8.5 Local Agency Comments and Responses

8.5.1 City of Marina (Marina)

**Re: Draft Environmental Impact Report/Environmental Impact Statement
Monterey Peninsula Water Supply Project**

TITLE:	Location Map	DATE:	3/23/17
LOCATION:	City of Marina Comments on MPWSP Draft EIR/EIS Monterey County, California	FIGURE:	1

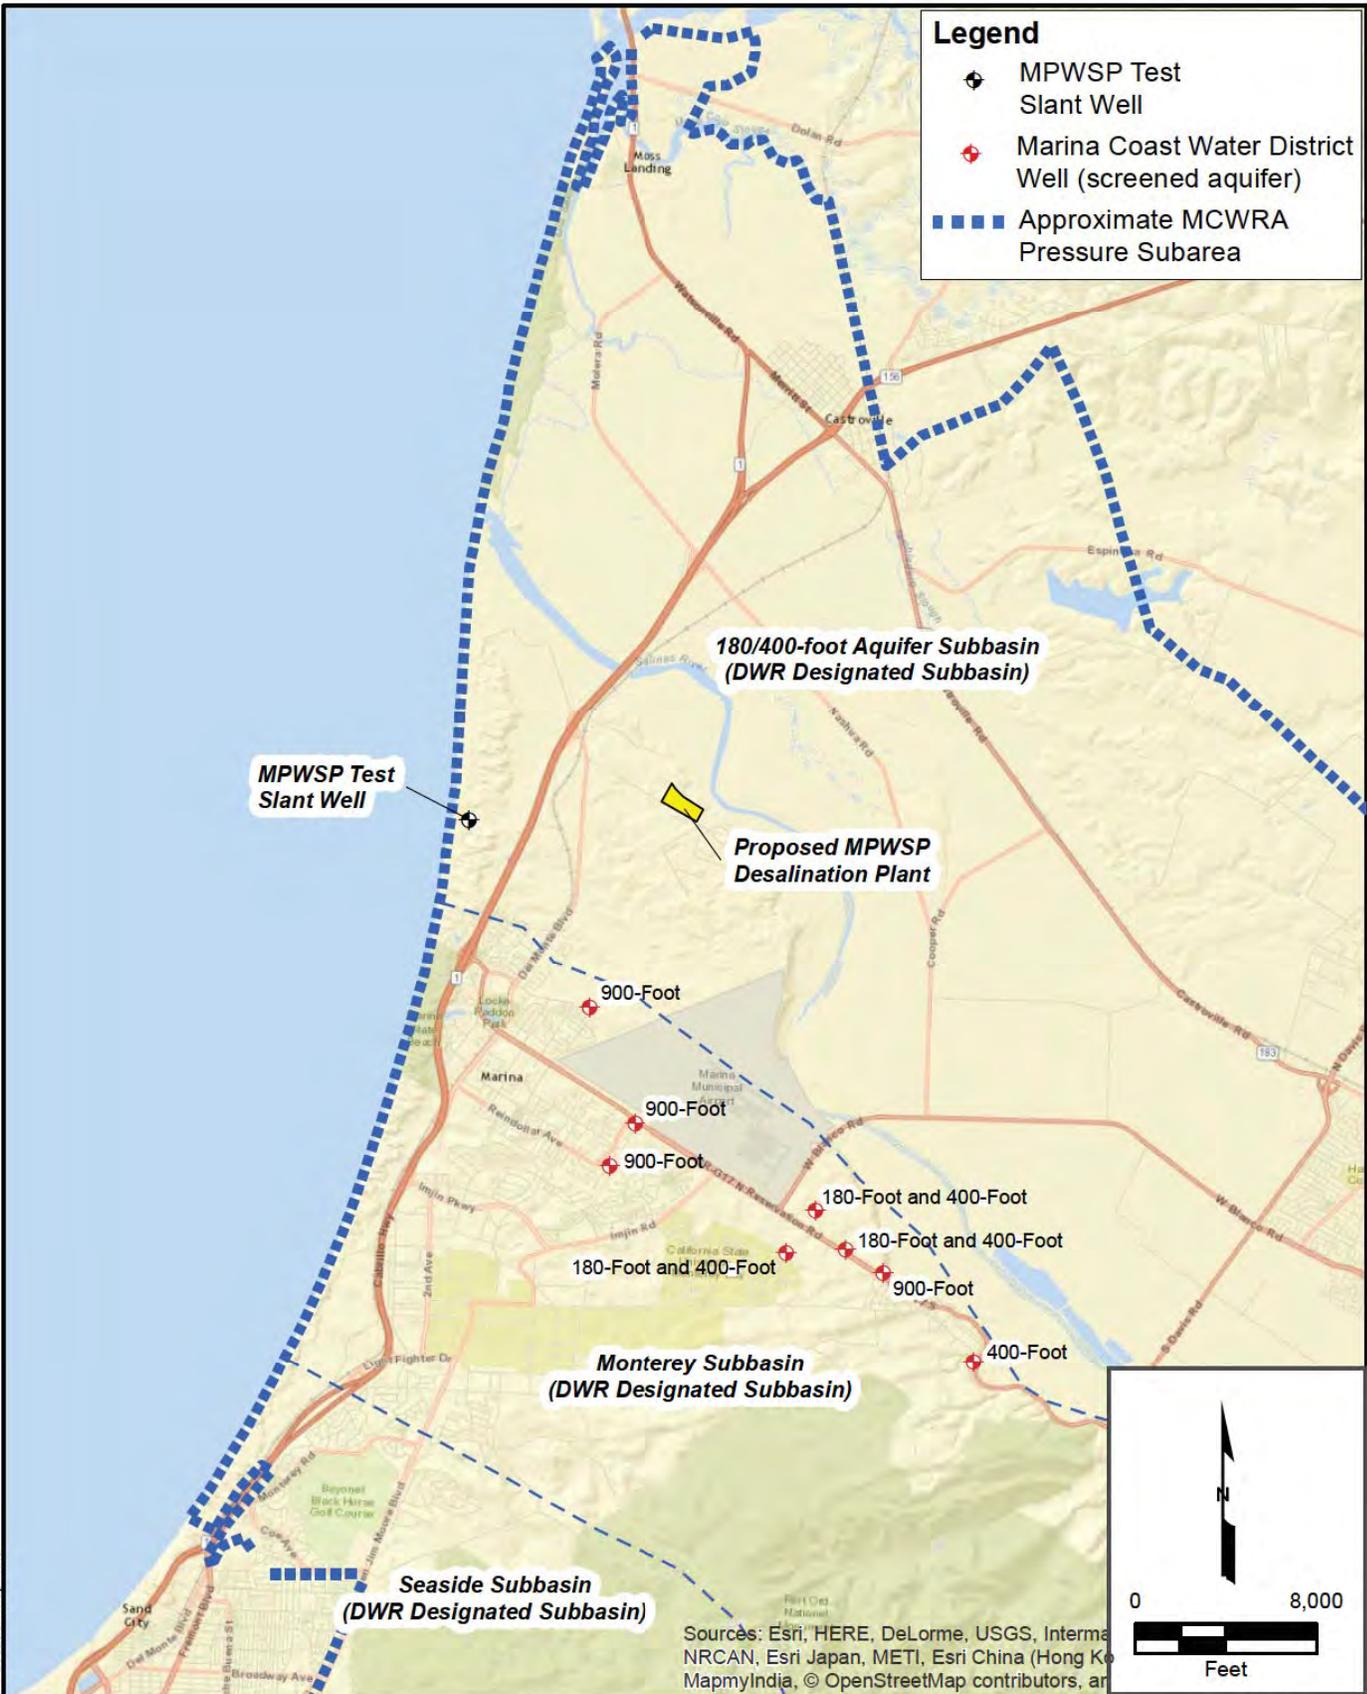
The proposed MPWSP includes a desalination plant with ten subsurface, seaward-facing slant wells to produce raw feedwater for the plant (Figure 1). These slant wells would pump up to 24.1 million gallons per day (MGD) of subsurface water from beneath the Monterey Bay coastline. The wells are proposed to be located on the CEMEX sand-mining property in Marina, California. The Draft EIR/EIS assumes that the plant feedwater will consist primarily of seawater that infiltrates through the seabed offshore from the CEMEX property. A test slant well is currently operating on this property. Alternative 5a, which has been designated the California Environmental Quality Act (CEQA) environmentally superior alternative and National Environmental Policy Act (NEPA) preferred alternative, would use seven slant wells on the CEMEX sand-mining property to pump up to 15.5 MGD of subsurface feedwater from beneath the Monterey Bay coastline.

Using designations defined by the Monterey County Water Resources Agency (MCWRA), the proposed MPWSP is located in the Pressure Subarea of the Salinas Valley Groundwater Basin (SVGB) (Figure 1).² Using California Department of Water Resources (DWR) designations, the MPWSP area is located in the 180/400-Foot Aquifer Subbasin of the SVGB.³ Wells operated by Marina Coast Water District (MCWD) that supply drinking water to the City of Marina are located in the Monterey Subbasin designated by DWR, which is located within the boundary of the Pressure Subarea of the SVGB designated by MCWRA (Figure 1). The MCWD wells are screened in the 180-Foot, 400-Foot, and 900-Foot aquifers.

JACOBSON JAMES & associates, inc	City of Marina Comments on MPWSP Draft EIR/EIS Monterey County, California			FIGURE 5 ERT Results and Interpretation along the Profile shown on Figure 4
	PROJECT NO. COM-001/01	DATE 3/23/17	DRAWN BY ML

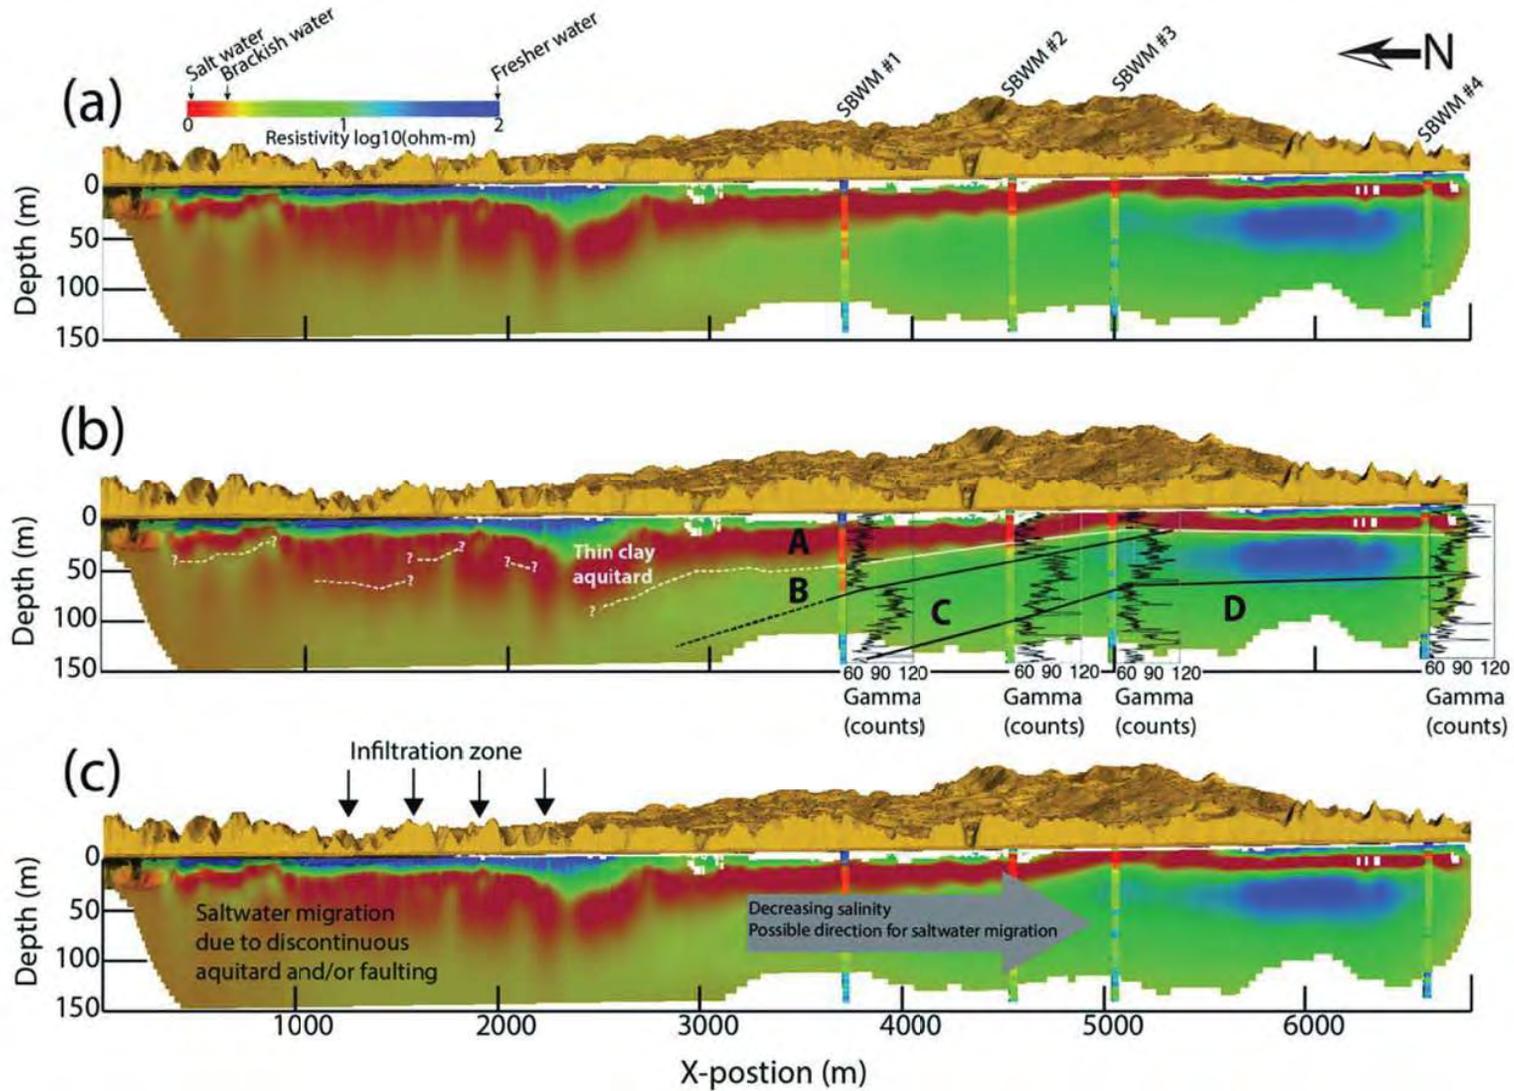
Pidlisecky et al. (2016) present results of ERT imaging over a 7-kilometer (4.3 miles) profile of the Monterey Bay coastline, which extended to a depth of approximately 150 meters (490 feet) (Figure 4). The color-coded plot of electrical resistivity across this area in Panel (a) of Figure 5 shows clearly the different resistivities associated with salt water (red) and fresh water (blue) in the principal aquifers. When combined with lithologic interpretations shown on Panels (b) and (c), the resistivity results delineate the aquifers, aquitards, and horizontal and vertical extents and migration pathways of

Figure 7: Simulated Capture Zone – No Background Gradient

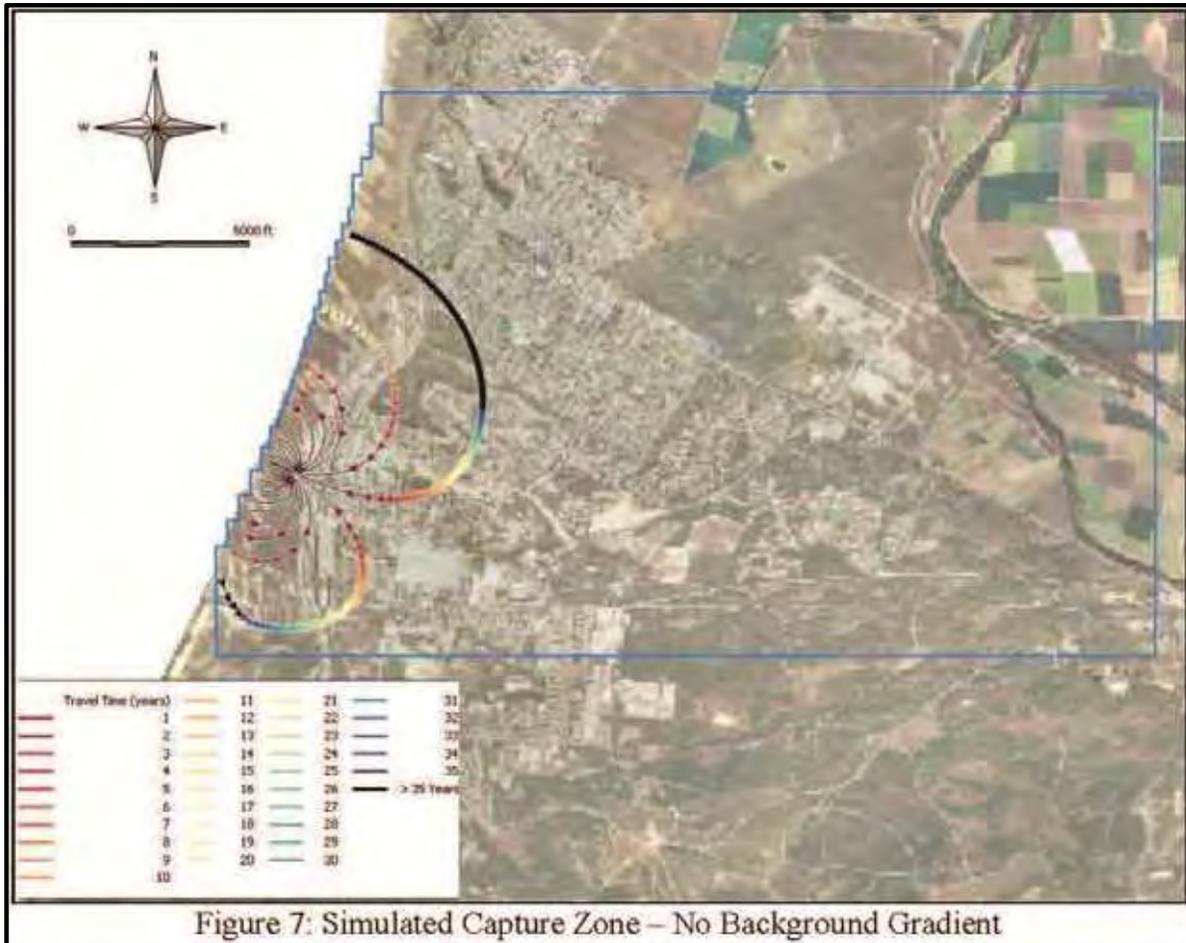
Again, this failure is fatal to the DEIR/EIS’s ability to reliably analyze the project’s potential groundwater impacts. Given the potential magnitude of the increased groundwater production, the impacts to the SVGB, in particular the Marina Subarea, the project’s potential impact on the Marina Subarea are very likely grossly understated by the superposition model. Therefore, a well calibrated model is needed to quantify the project’s potential impacts with a reasonable scientific basis. Specifically, a model that utilizes all the recharge and discharge components included in the older SVIGSM, and constructed with a level of detail reflecting our present understanding and knowledge of the hydrogeological system in the Marina Subarea is needed. Moreover, because seawater is an issue, a dual density model should be used to allow calculation of the head differences between the ocean water offshore and onshore, and freshwater in the aquifer zones inland and to allow prediction of water quality changes and the concentrations of feedwater that would be produced by the proposed project.

Diagram 5 – Percent Groundwater and Ocean Water with Distance from the Shoreline

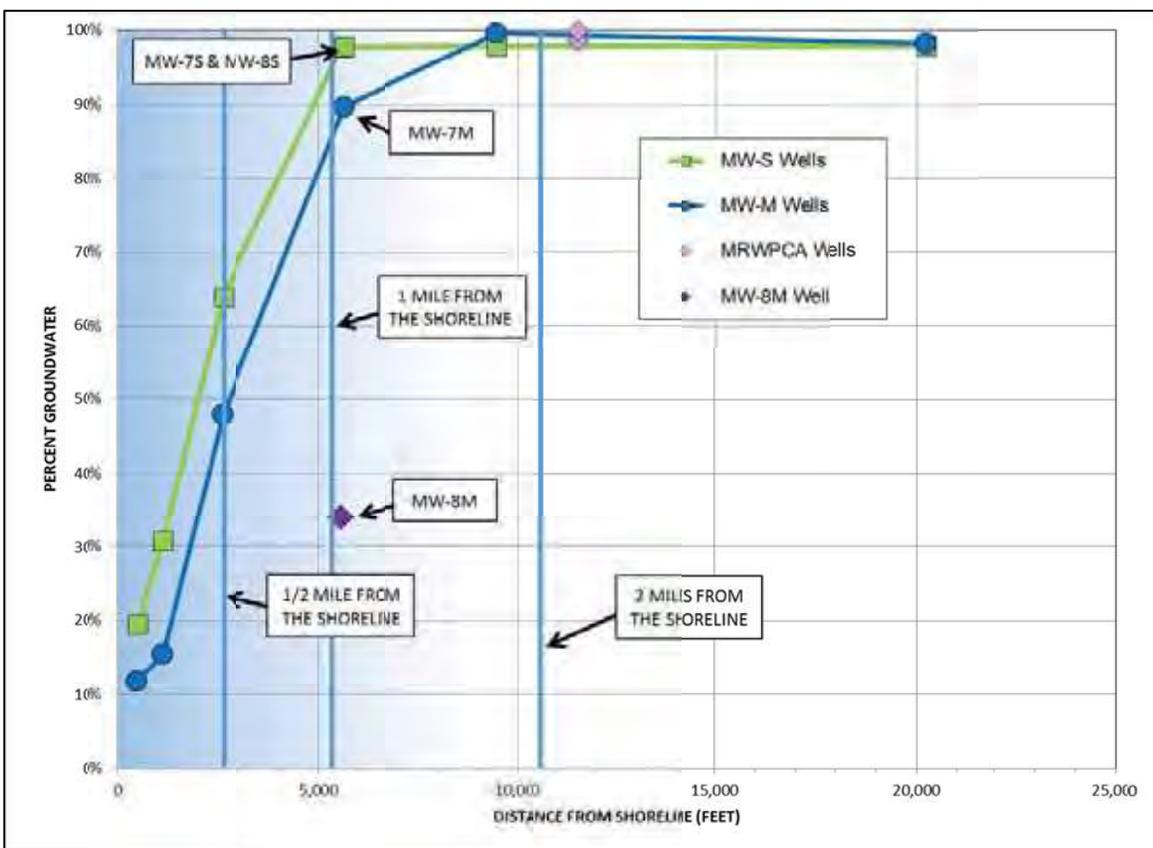
As noted above, the MCWRA maps used to justify the DEIR/EIS position are included with this response letter and include recent data from the TSW project that contradict the blanket statement that the freshwater/seawater interface is 8 miles inland (see attached Figures 1 through 5 and Diagram 5). Moreover, MCWRA does not have any maps for the extent of seawater

Diagram 7 – CEMEX Surface Water Features August 2013

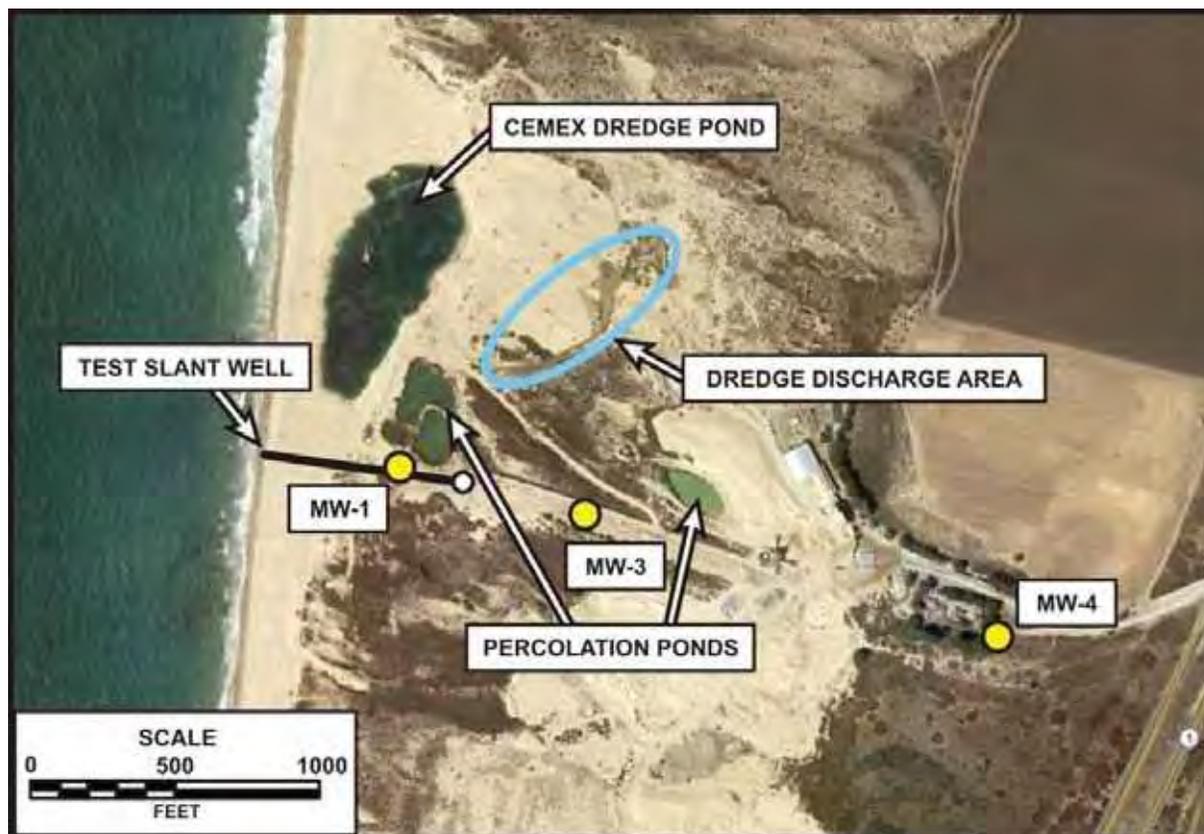
that are not present at other locations along the coast in particular where the other source water wells are proposed.

**FIGURE 6
DUNE SAND AQUIFER
GROUNDWATER ELEVATION
CONTOUR MAP**

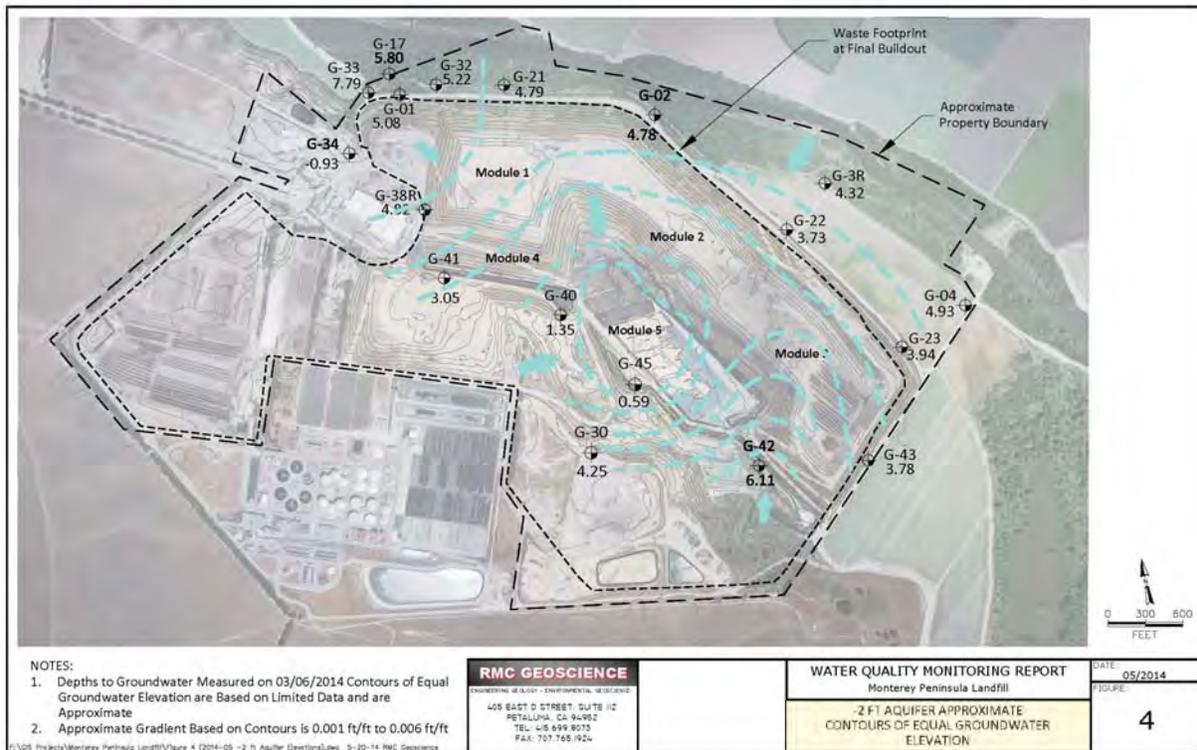
the ocean and thus are protective of seawater intrusion. (See e.g., HGC comments, p. 70; see Figure 6 attached to same.)
